#### **Addendum 128– UN Regulation No. 129**

#### **Revision 2 – Amendment 2**

Supplement 2 to the 02 series of amendments – Date of entry into force: 19 July 2018

#### **Uniform provisions concerning the approval of Enhanced Child Restraint Systems used on board of motor vehicles (ECRS)**

Figure 2

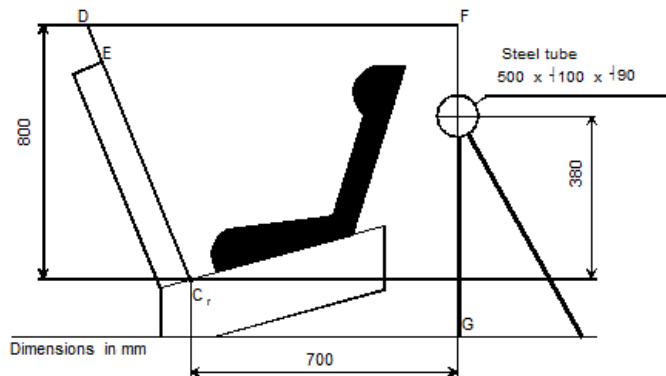
*Paragraph 6.6.4.1.2.1.*, amend to read:

"6.6.4.1.2.1. Head excursion: no part of the head of the dummy shall pass beyond the planes FD, FG and DE, as shown in Figure 2 below. This shall be judged up to 300 ms or the moment that the dummy has come to a definitive standstill whatever occurs first.

Except when testing using Q6 dummy where:

The value in relation to the FD plane is 840 mm

Where a test is conducted with paragraph 6.6.4.1.6.2. or paragraph 6.6.4.1.8.2. above, only the second configuration test results without 100 mm diameter bar will be considered.

Figure 1

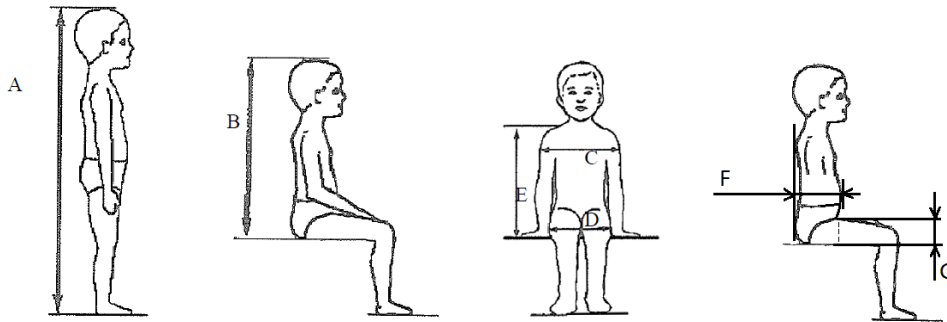
Annex 18, amend to read:

All lateral dimensions are measured under a contact force of 50 N with the devices described in Figure 2 and Figure 3 of this annex and the following tolerances will applied:

Minimum Sitting height:

- (a) Up to 87 cm B - 5 per cent;
- (b) From stature from 87 cm and up to 150 cm B - 10 per cent.

Minimum shoulder height (5 percentile): E1  $-2^{+0}$  cm

Maximum shoulder height (95 percentile): E2  $-0^{+2}$  cm

Figure 2  
**ECRS Measurement Device - Side and Front View of the measuring device**

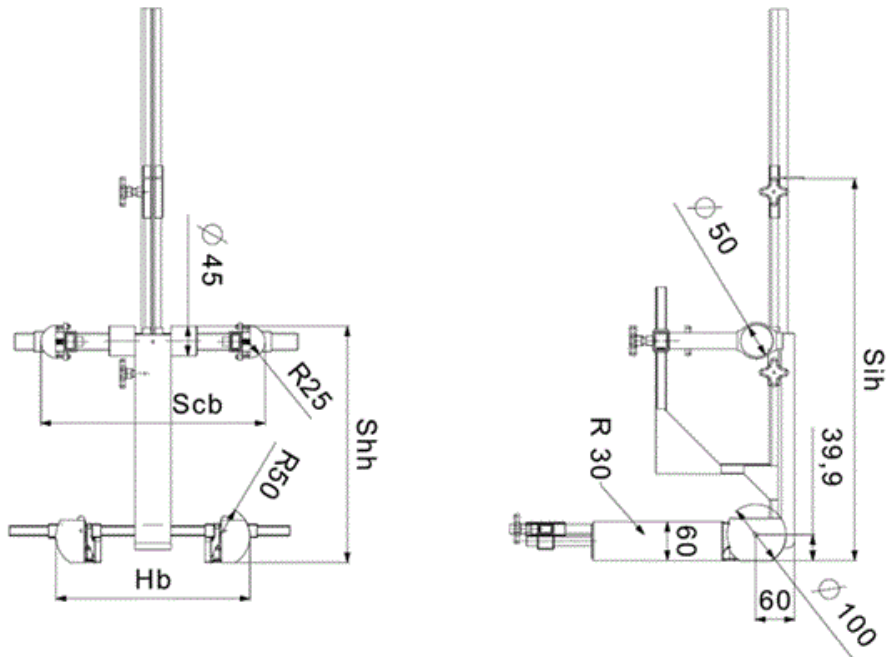
The mass of the devices described in Figure 2 and Figure 3 of this annex shall be 10 kg +/- 1 kg

For integral or non-integral ECRS the device shown in Annex 18, Figure 2 shall be used.

Figure 3  
**Side and Front View of the measuring device for measurements applicable to Enhanced Child Restraint Systems that feature an impact shield**

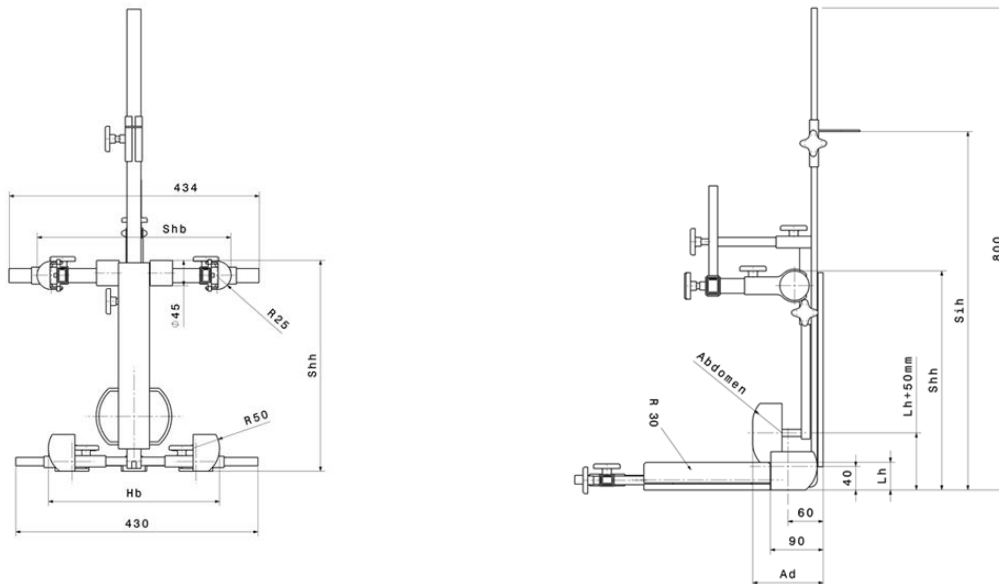
For ECRS with an impact shield the device shown in Annex 18, Figure 3 shall be used.
